URBAN AND LANDSCAPE DESIGN SECTOR PLAN: MOIR HILL CONSTRUCTION YARD

Ara Tūhono
**Pūhoi to
Warkworth**
A NZ Transport Agency PPP Project

Moir Hill Construction Yard

Figure 2. Site Layout Plan 1:1000 @ A3

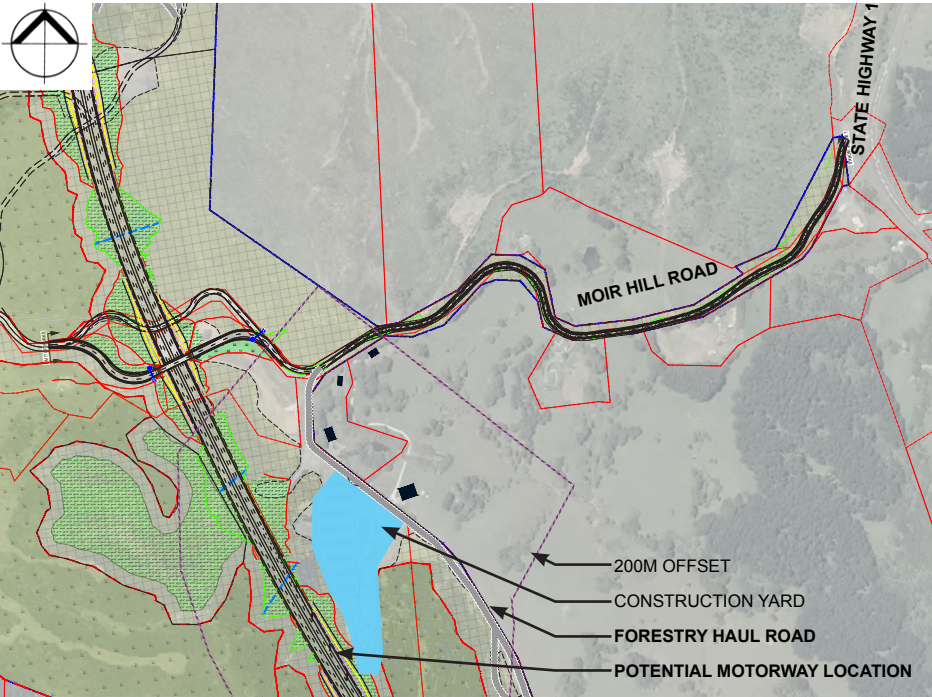
Options to construct a fence or barrier to give privacy and deflect noise to 101 Moir Hill Rd?	Agree	In response to feedback from this stakeholder, the NX2 team meet the landowner and proposed a timber screen fence to run the from the corner of Moir Hill Road down the eastern side of Wreaks Road and passed the house to provide a better screening option (than the 1m high planted bund initially proposed). The fence, likely plywood screens, approximately 2.5m high, located on the roadside and offset from the existing boundary fence would stay up for the period of construction works. The owner confirmed they were happy with the fence proposed. As a result of adding the fence, the construction yard site will not be visible to the neighbours.
Requested a copy of final plans.	NA	The BOI conditions require NX2 to send copies of final plans to stakeholders. This UDLSP provides the final plans.
Raised issue with early morning noise from a generator.	Agree	NX2 can confirmation that the subject noise was being produced by a generator charging forestry radios. The generator has now been automated to turn off after-hours.

Requested a higher earth bund than what was shown (c. 2m high) to provide better screening than a 1m bund with plants.	Agree	In response to feedback from this landowner, the NX2 team have removed the earth bund and plants, and suggested a fence. The fence is likely to be 2.5m high, located on the roadside and offset from the boundary fence. The fence is to stay up for the period of construction works. As a result of adding the fence, the construction yard site will not be visible to the neighbours.
The current layout shows the hazardous goods area and toilet block located close to the road. Will the hazardous goods area be used to store explosives? Can the toilet block be moved?	Agree	The Moir Hill construction yard does not include any storage for any explosives. Explosives will be delivered to the construction area (not the construction yard) each morning, and any unused explosives will be taken offsite, back to the factory each afternoon. The items to be stored in the construction yard area include machine oils and lubes, paints, resins, concrete retardants, small hand held containers of fuel etc. NX2 have re-oriented the buildings within the construction yard to provide additional screening between this property and have moved the hazardous goods and toilet area further back.

The view of the yard from the dwellings within 200m is partially screened with some existing vegetation, but this screening isn't continuous. Based on feedback from stakeholders, we propose to reduce views from the two adjacent properties by installing a 2.5m high fence adjacent to the construction yard.

The front door of the house at 99 Moir Hill Road is located opposite an informal entrance which creates a view to the proposed yard (the legal driveway is access from a different area on Moir Hill Road). Screening this view will be a 2.5m high timber fence which will run along the boundary of the property, adjacent to the yard (refer to Figure 2).

The House at 101 Moir Hill Road will have a less direct view to the construction yard. The existing vegetation which currently screens that view will be retained. It contains a mix of mature poplars (6-8m+ high) and other medium sized deciduous and evergreen shrubs. A 2.5m high timber fence will also run along this boundary, adjacent to the construction yard. This will screen construction yard operations from this property.
